MEMORANDUM

TO: Sudbury Planning Board
FROM: William C. Henchy, Counsel to Quarry North Road LLC
RE: Sudbury Zoning—Section 4200
Date: March 3, 2020

Prepared by
GeoHydroCycle, Inc.

Figure 10. Simulated
Mounded Seasonal
High Groundwater
Contour Elevations,
Wastewater Discharge:
80% of 49,755 GPD.

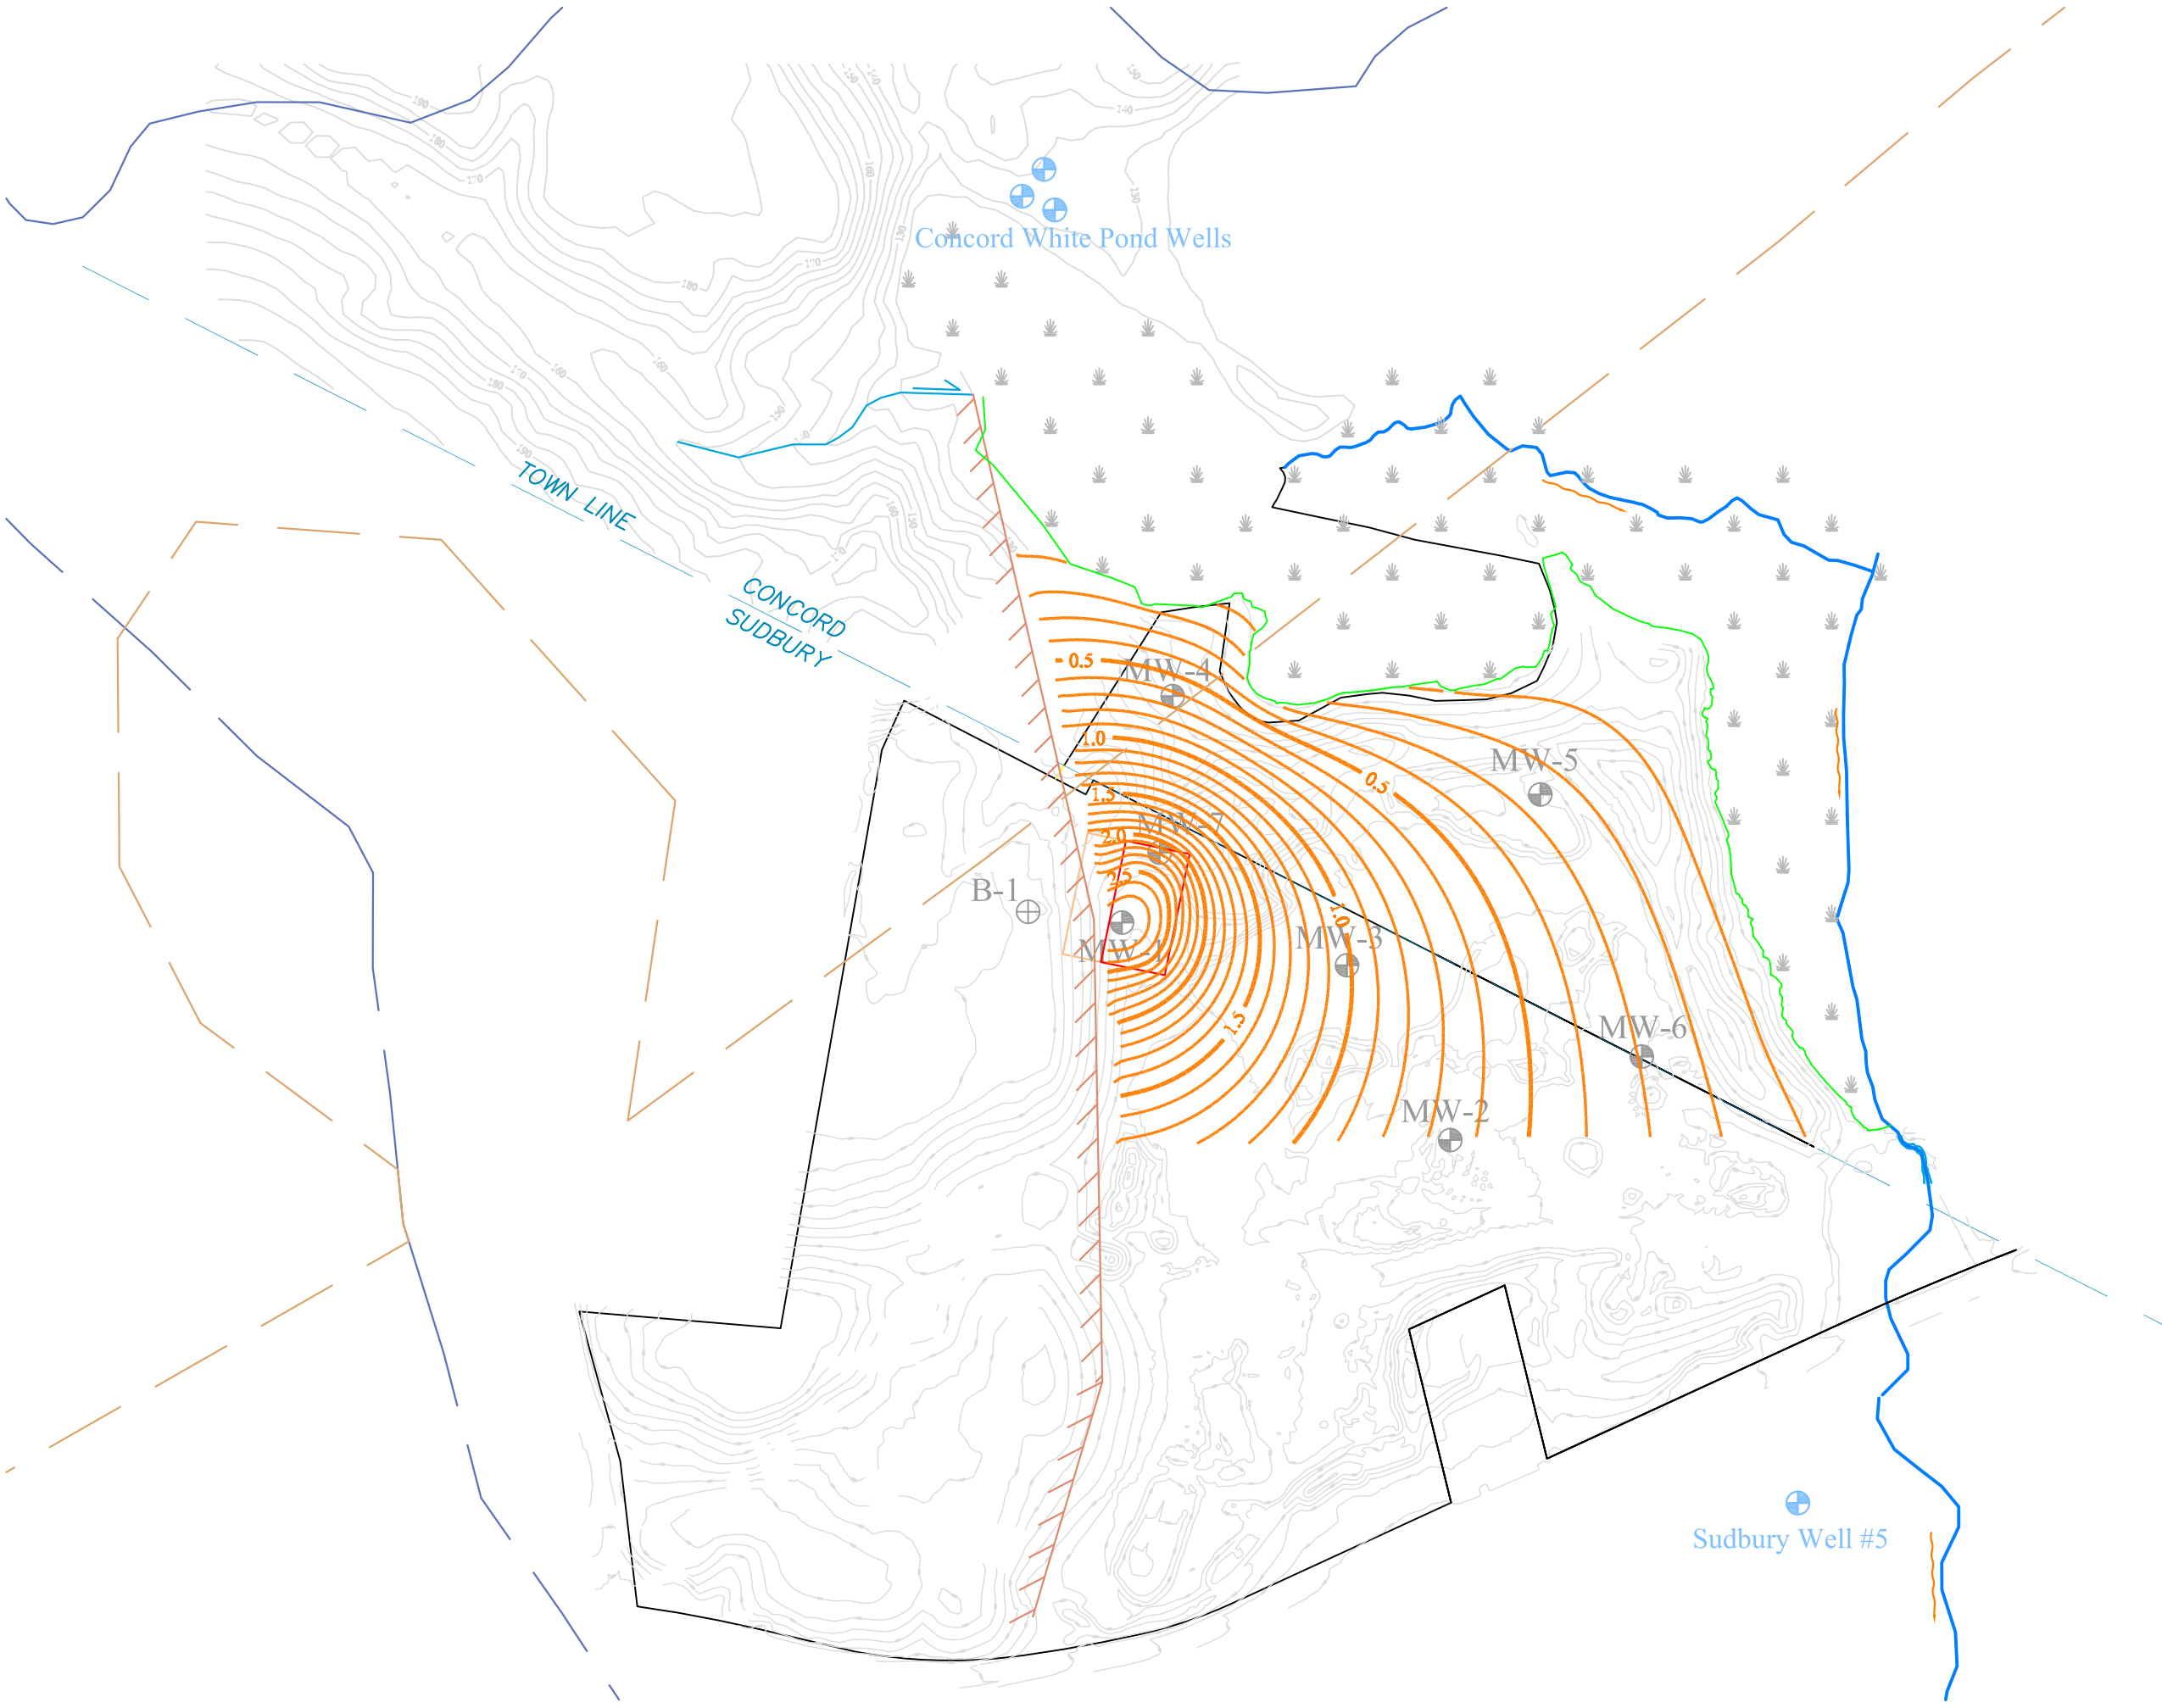
Based on our review of the proposed monitoring well locations and the flow field as illustrated in Figure 10, we agree, based on our review of currently available data, that CMW-1, CMW-2 and CMW-3 are appropriately located. CMW-1 should be outside of the influence of the proposed discharge and based on Figure 13, CMW-2 and CMW-3 are downgradient of the proposed SAS location. Further sampling of the three monitoring wells will provide more details on the suitability of the well location.

Figure 13. Proposed
Locations of
Compliance Wells.

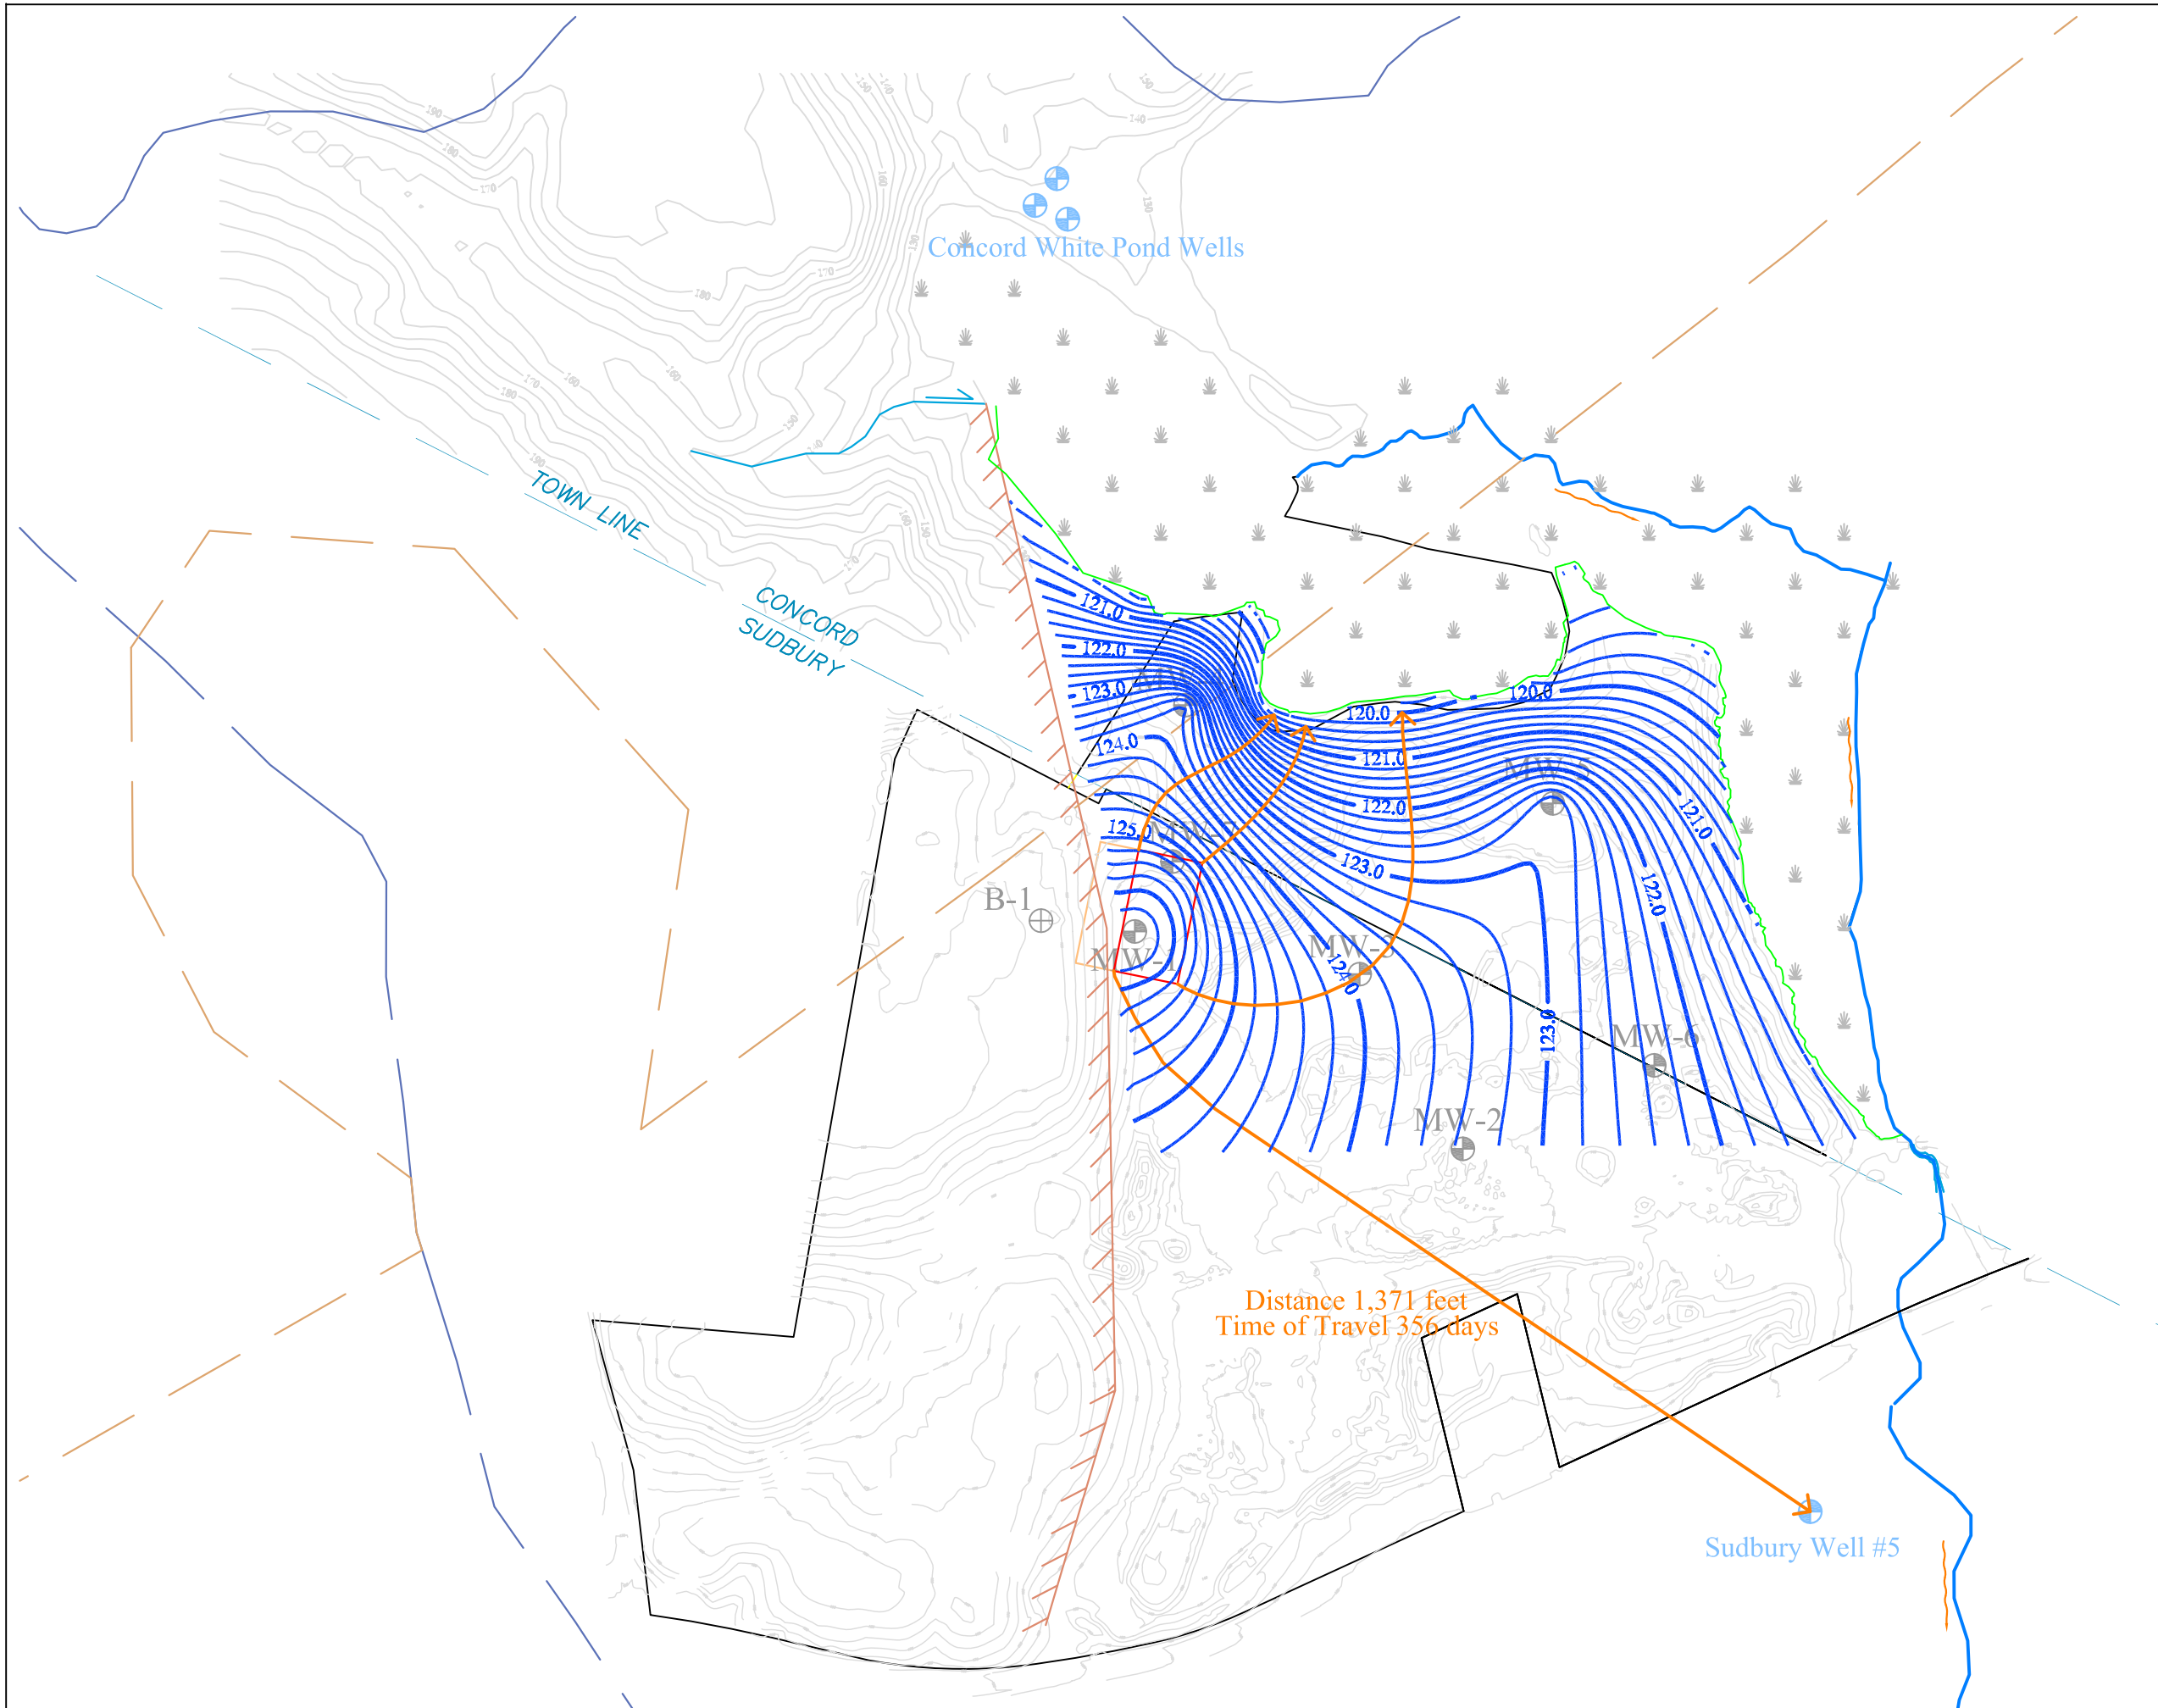
- 3) The proposed SAS shall not be constructed until a Groundwater Discharge Permit has been obtained from MassDEP. The proposed SAS shall be constructed within the footprint indicated on Figure 13 titled "Proposed Locations of Compliance Wells" of the August 7, 2019 Hydrogeologic Evaluation Report.

- 5) MassDEP approves the use of monitoring well locations as shown in Figure 13, titled "Proposed Locations of Compliance Wells" of the Report and understands these will remain unchanged. Any changes to the monitoring well network are to be submitted to this office for approval prior to well installation. MassDEP requires all monthly sampling of the monitoring wells beginning from the issuance of this approval to be submitted along with the Individual Groundwater Discharge application. The location of the monitoring wells will be subject to further review and approval during that time.
